**RELEASED FOR  
 FABRICATION / INSTALLATION**  
 PPPL Drafting:

Oak Ridge National Laboratory managed for the DEPARTMENT OF ENERGY under U.S. GOVERNMENT contract DE-AC05-00OR22725 UT-BATTELLE, LLC, Oak Ridge, Tennessee PROJECT NAME						
NATIONAL COMPACT STELLERATOR EXPERIMENT VACUUM VESSEL PERIOD INSPECTION AND LEAK CHECK ASSEMBLY						
VERSION NO.	PLANT	BLDG	FL	SHT OF	TYPE	CLASS
5	X-10	5700	3	2 19	A	U
RELEASE LEVEL		SE120-004			REV	
Fabrication					2

TYPICAL PORT 4A AND 4B  
SECTION PORT04A-PORT04A

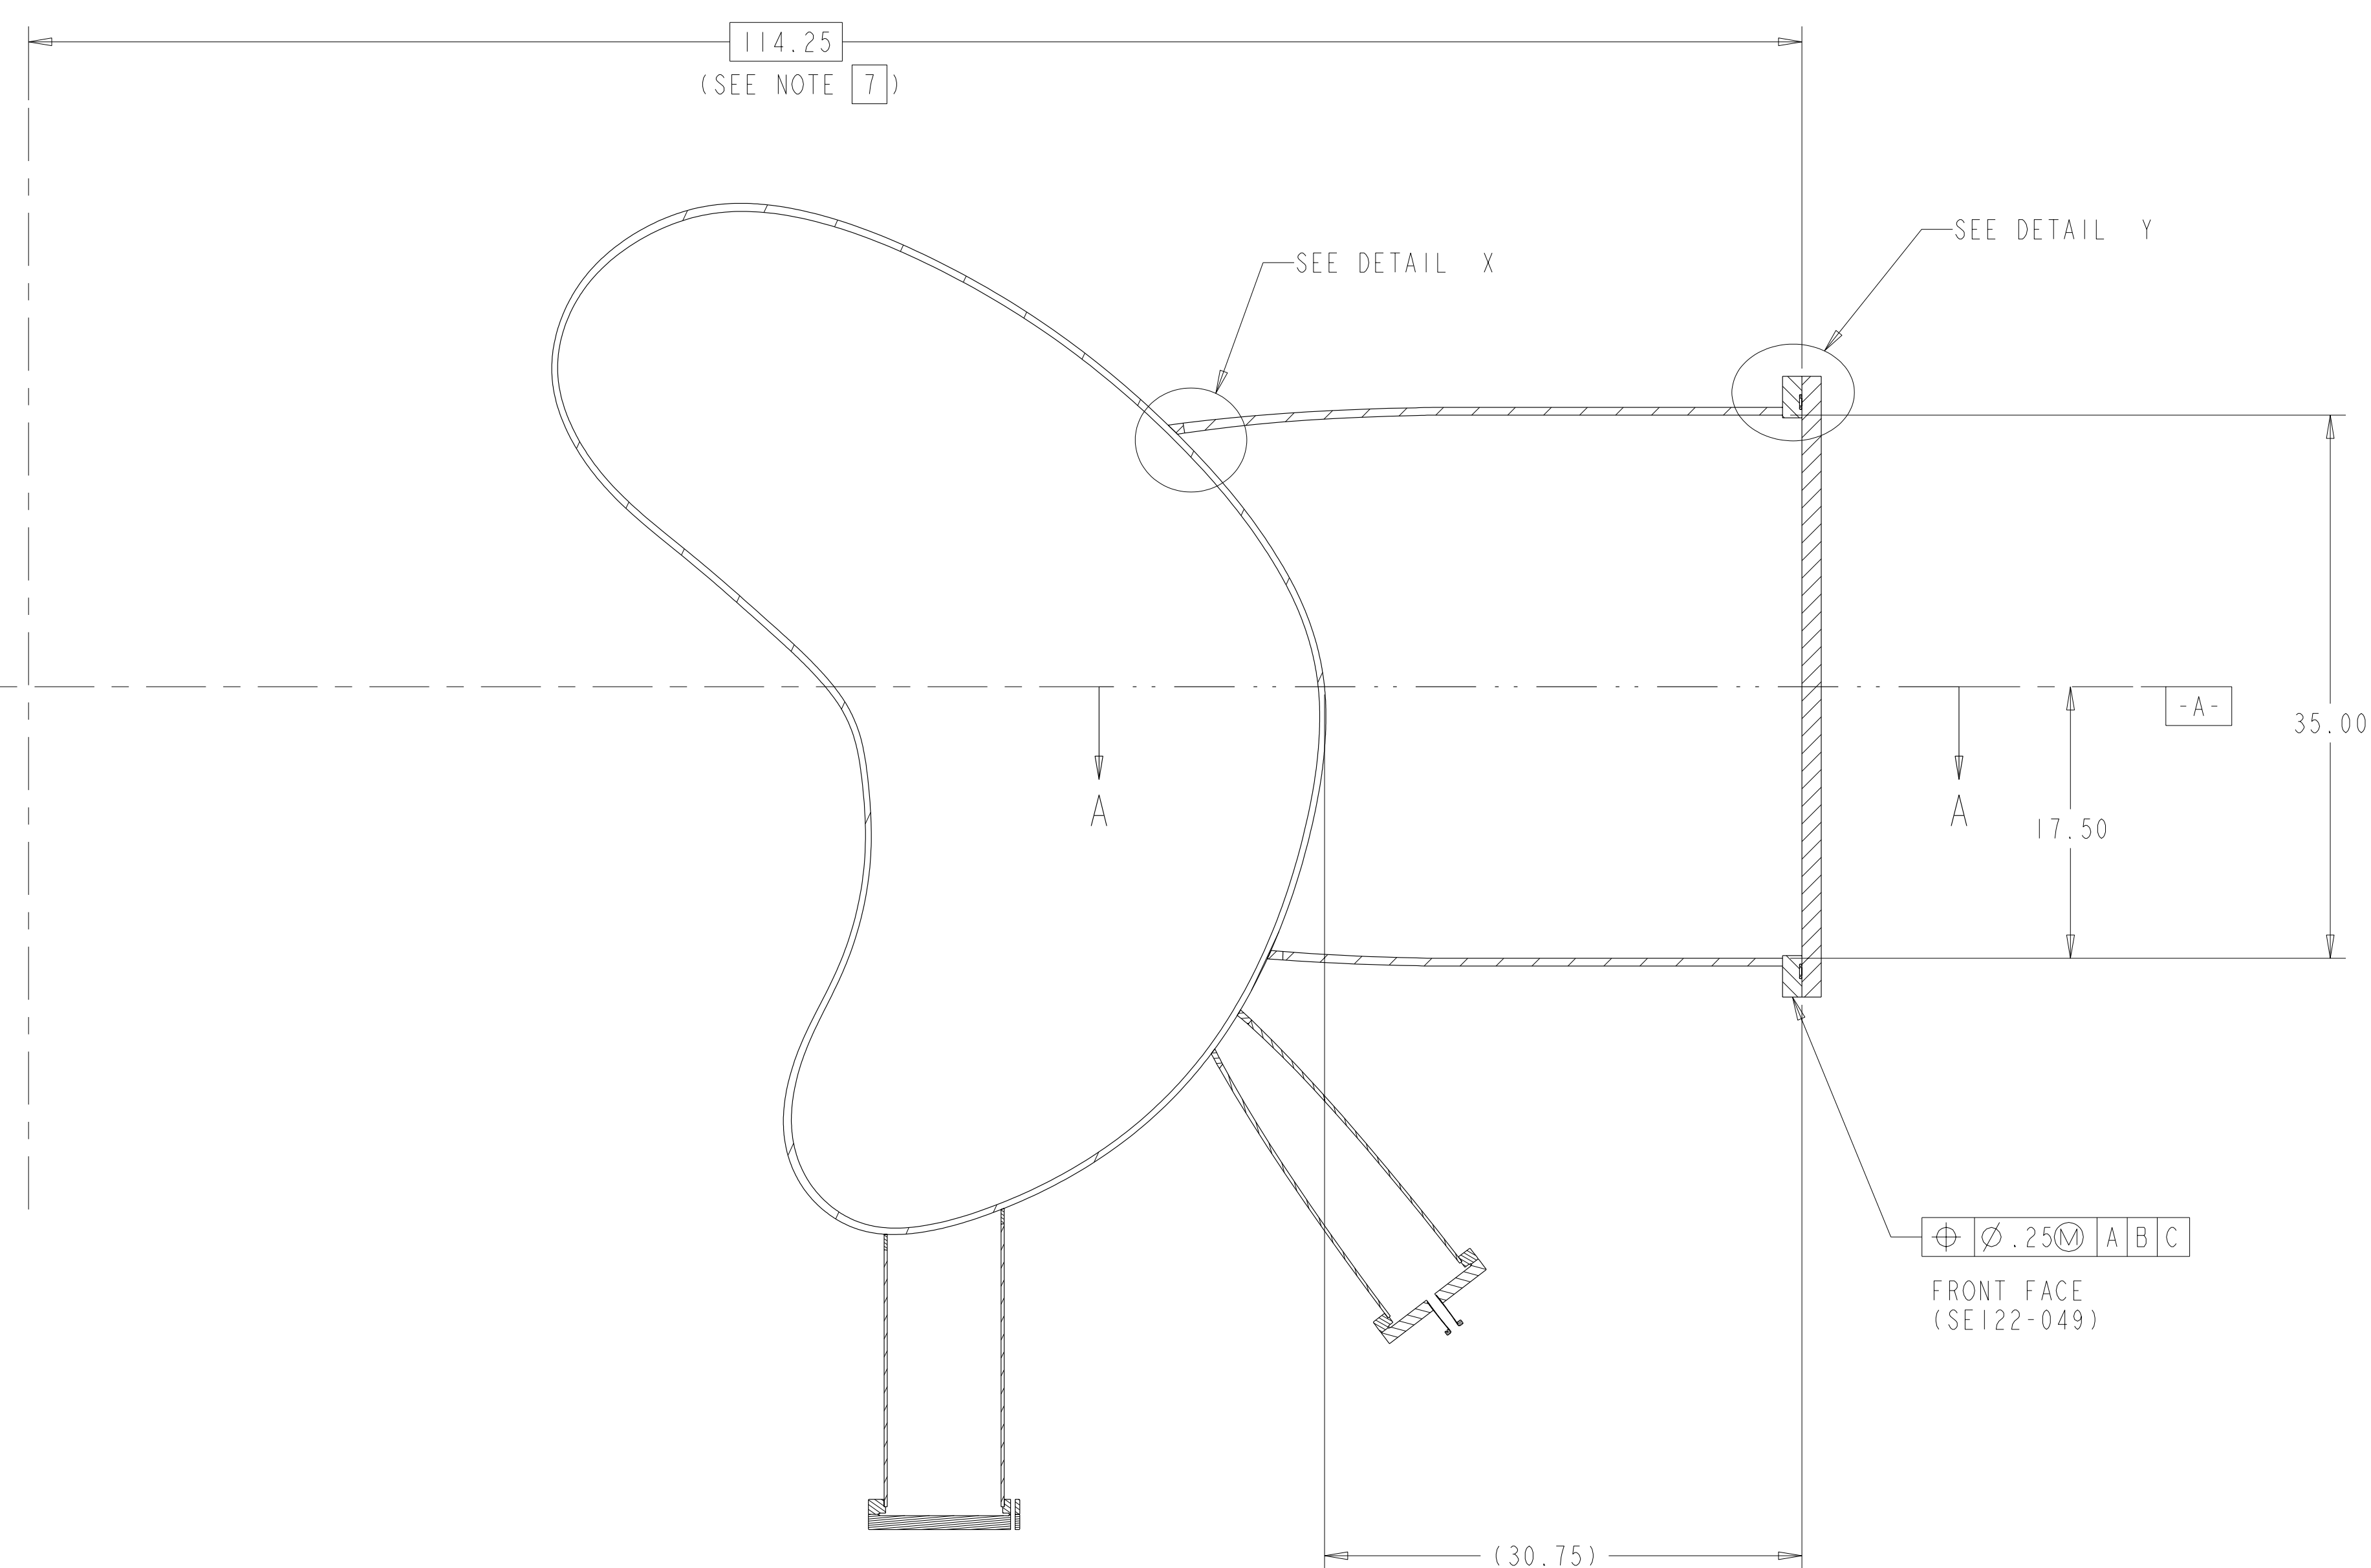
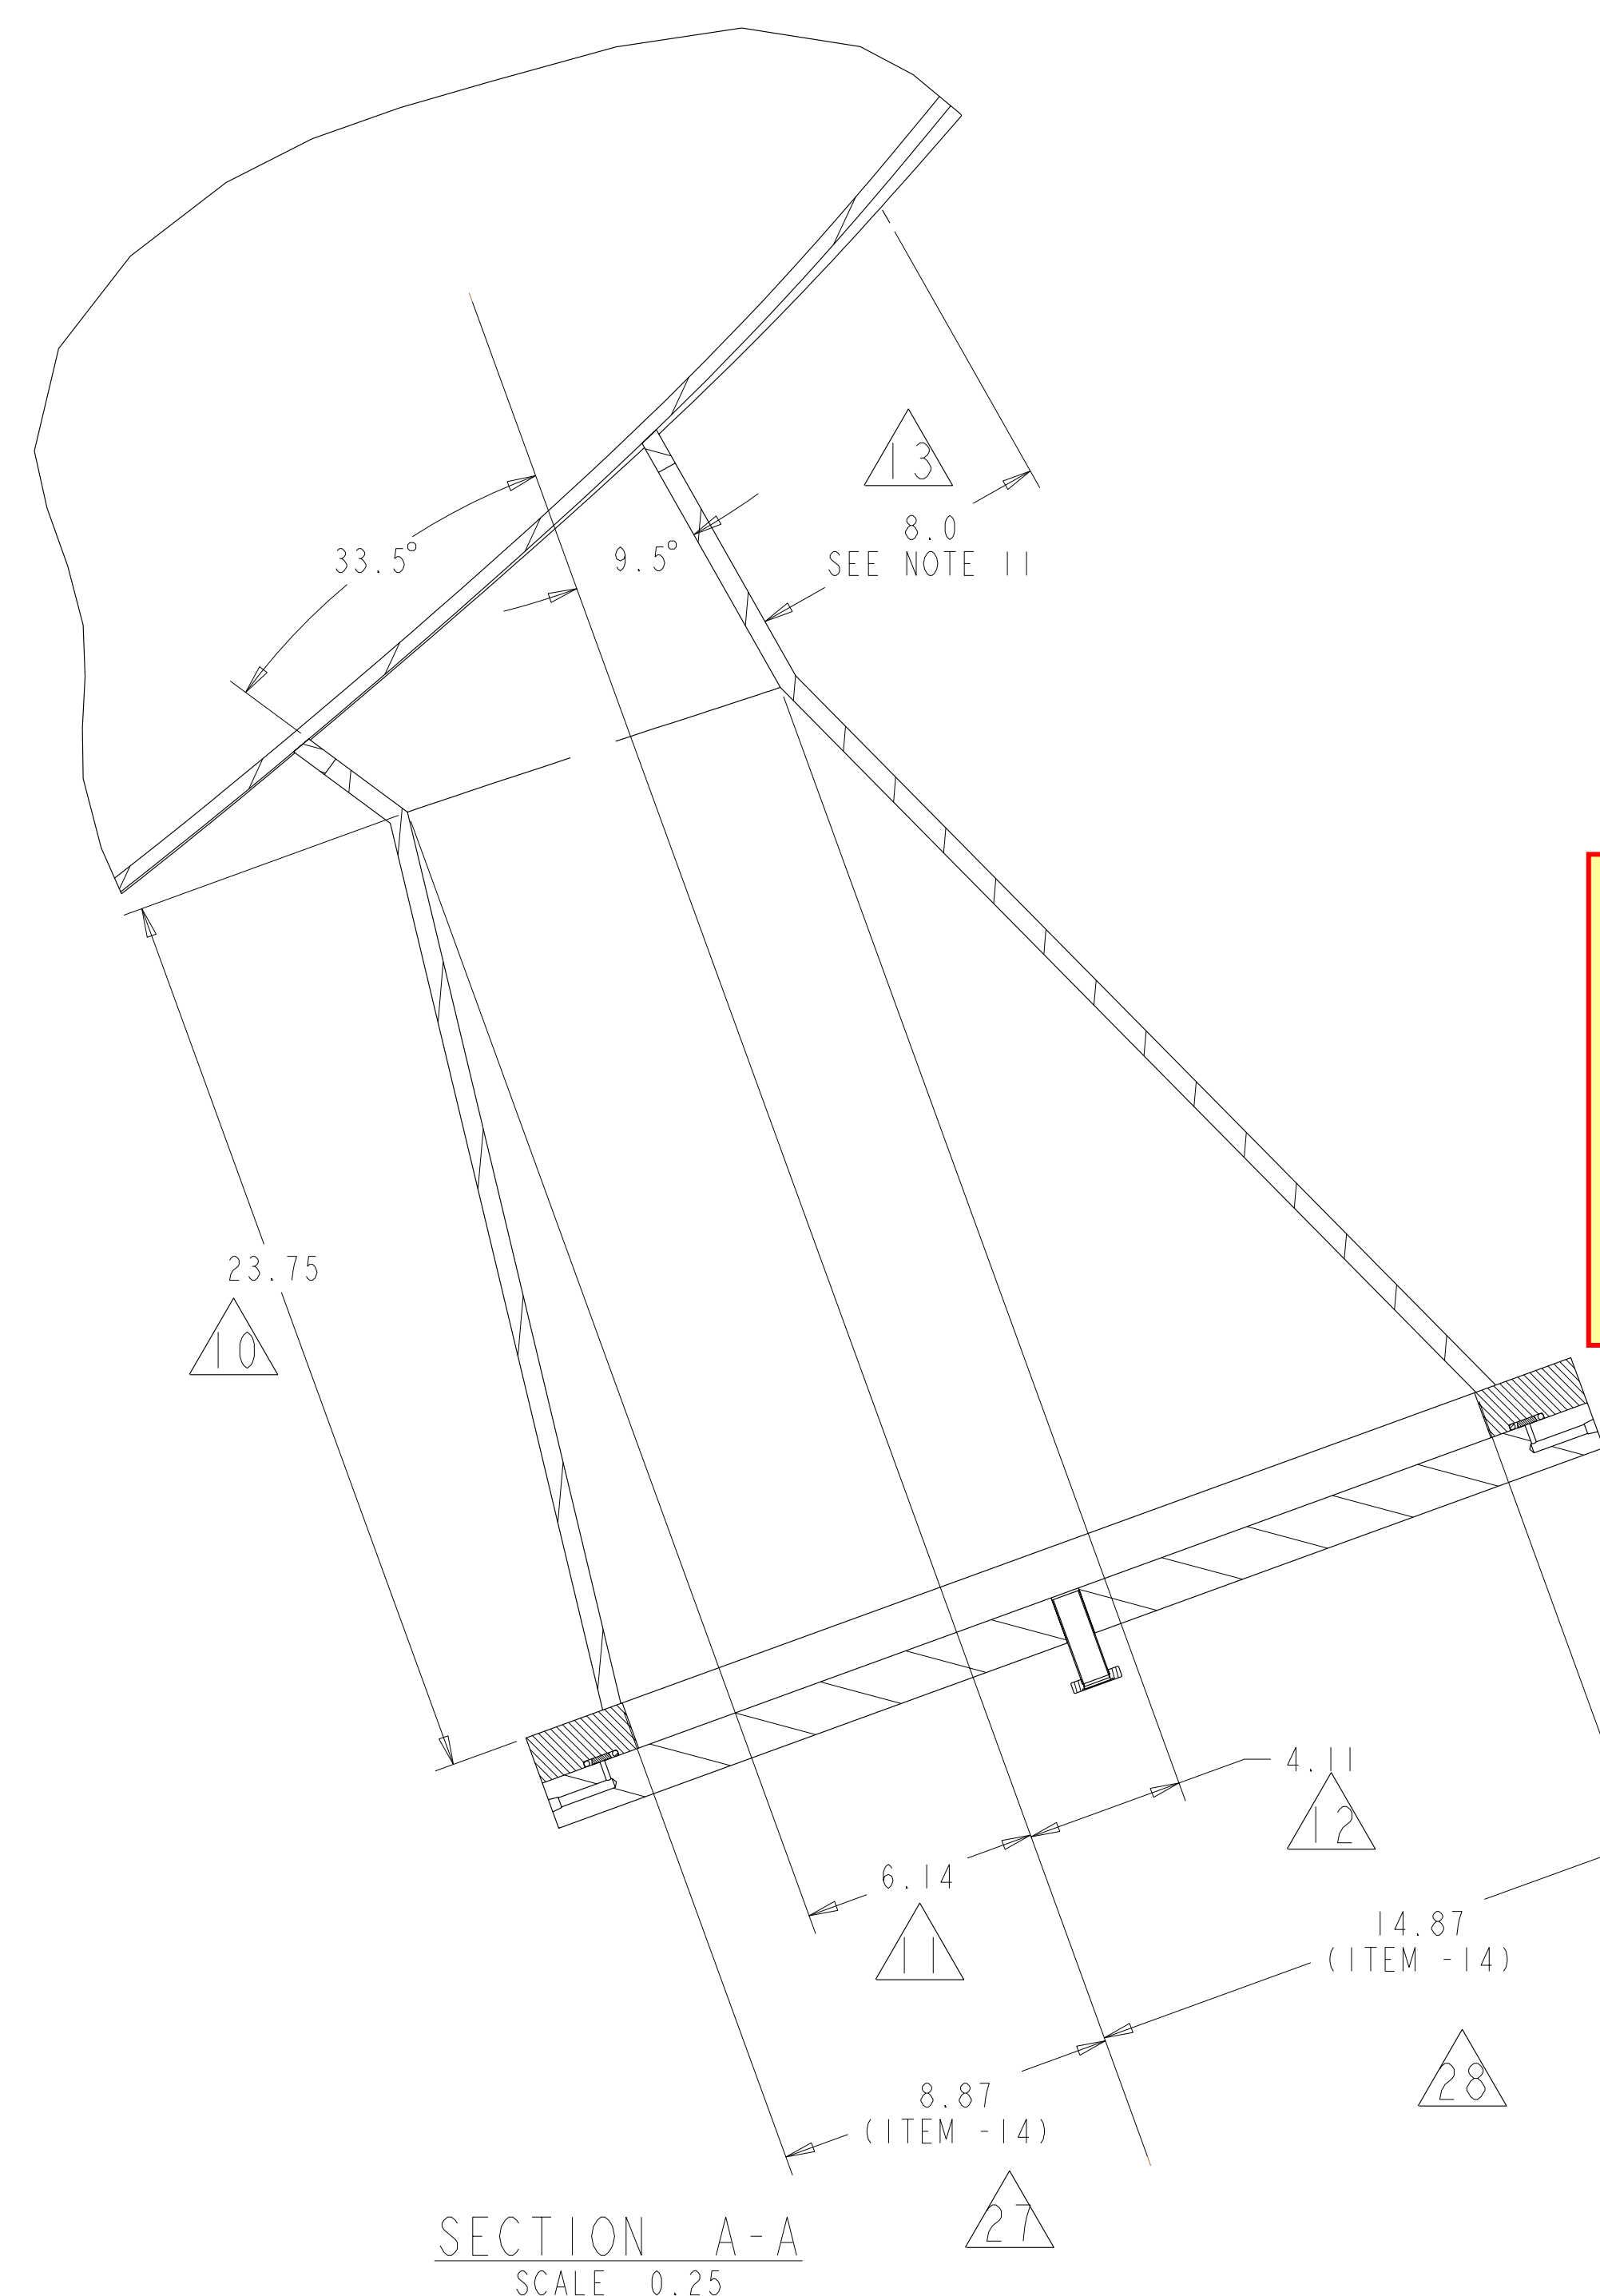
**Rev 2-e: ECN-5021 (RFD-12-017) approved alternate methods for welding the port extensions to the VVSA (See ECN-5021 for details). - Only applicable to VVSA #3 - VVSA #1 and #2 covered by NCR 19464.**

**ECN-5082.** Requirement originally included grooves to facilitate leak checking by vendor. However, vendor elected another means of leak checking and therefore the grooves are no longer required. Specifically, this ECN eliminated the leak checking groove on SE121-014 (Rev 1-c) and SE1221-091 (Rev 0-a). Additionally, this ECN added a missing weld symbol to SE121-004 (Sheets 4 through 19) for joining the port extensions to the vessel (Rev 2-d).  
**(See ECN-5082 for details)**
